WELL API NO. 30-015-03187
5. Indicate Type of Lease STATE <input checked="" type="checkbox"/> FEE <input type="checkbox"/>
6. State Oil & Gas Lease No. B-1266
7. Lease Name or Unit Agreement Name State I
8. Well Number #16
9. OGRID Number 229137
10. Pool name or Wildcat GRBG Jackson, SR-Q-GRBG-SA

SUNDRY NOTICES AND REPORTS ON WELLS
(DO NOT USE THIS FORM FOR PROPOSALS TO DRILL OR TO DEEPEN OR PLUG BACK TO A DIFFERENT RESERVOIR. USE "APPLICATION FOR PERMIT" (FORM C-101) FOR SUCH PROPOSALS.)

2. Name of Operator
COG Operating, LLC

Lease & Well # State I #16

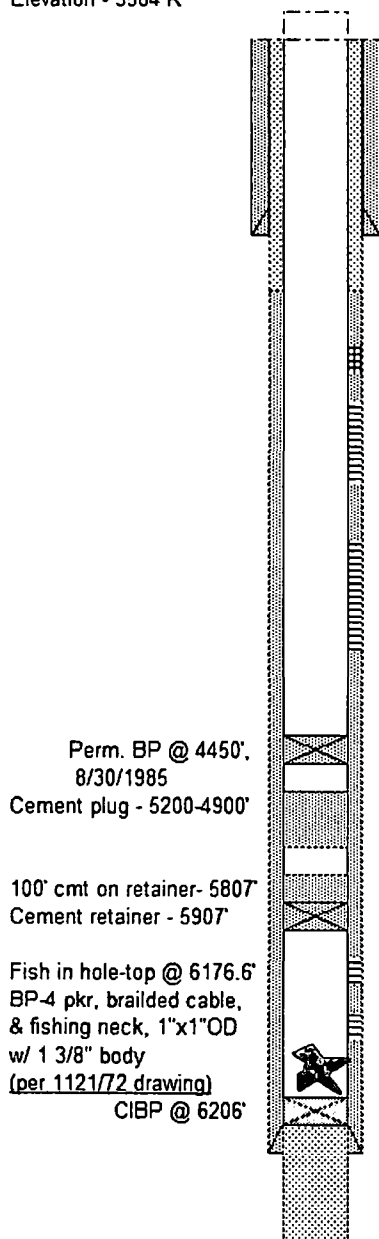
Notify NMAC 24 hrs before work

*Test csg before 25 sx cmt
Perf @ 2344-2494 were squeezed*

Must be Plugged by 7-3-19
